Amphenol PCD

Engineering Change Request		ECR Number	10415W	
Initiator:	Wayne	Date:	2026.06.22	
Part number description				
Item	K3 Code material part numbers	Drawing/ Doc Number	Version of current related document	New Version
1	See attached list of changed part numbers	/	/	/
2	/	/	/	/
Reason of change:				
<input type="checkbox"/> Customer requirement (list the feasibility analysis of customer specification: _____) <input type="checkbox"/> Supplier request (list the PCR number: _____) <input type="checkbox"/> internal improvement <input type="checkbox"/> corrective <input checked="" type="checkbox"/> other				
<u>Please describe here in detail:</u>				
To improve the salt spray resistance of the locking screws on the back cover of the Gen3 CCS2 socket, the salt spray requirement has been upgraded from 96H to 240H. This change is solely for enhancing the product's salt spray resistance rating and has no impact on its original functionality..

To improve the salt spray resistance of the locking screws on the back cover of the Gen3 CCS2 socket, the salt spray requirement has been upgraded from 96H to 240H. **This change is solely for enhancing the product's salt spray resistance rati

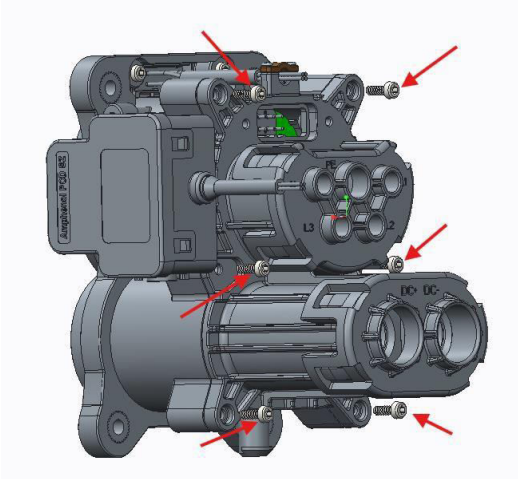
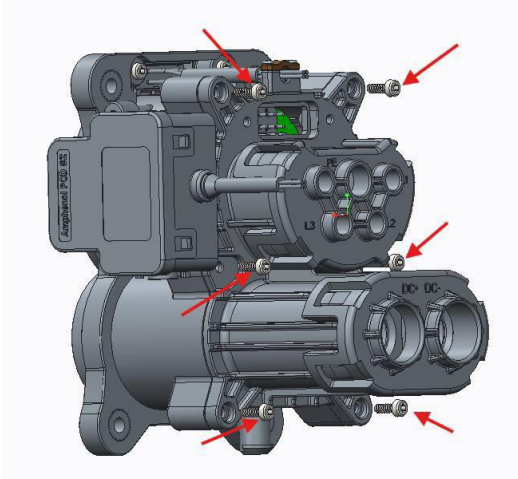
Before change	After change	
<p>1. Salt spray requirement: 72H; Specification: ST2.9×10; Color: Silver</p> <p>2. Part number: C210006302</p> <div style="text-align: center;">  </div> <div style="text-align: center;">  </div>	<p>1. Salt spray requirement: 240H; Specification: ST2.9×12; Color: Grey</p> <p>2. Part number: P01BM00214</p> <div style="text-align: center;">  </div> <div style="text-align: center;">  </div>	
<p>Disposition of old materials</p> <p> <input type="checkbox"/> Rework <input checked="" type="checkbox"/> Use as it is <input type="checkbox"/> scrap <input type="checkbox"/> Other (please describe) : _____ <input type="checkbox"/> N/A </p>		<p>Expect date to switch to new material</p> <p style="text-align: center;"><u>2026.07.15</u></p>
<p>Approval by the supervisor of requester.:</p> <p style="text-align: center;"><i>Jank</i></p>	<p>Approval by the head manager of the request dept.:</p> <p style="text-align: center;"><i>Justin</i></p>
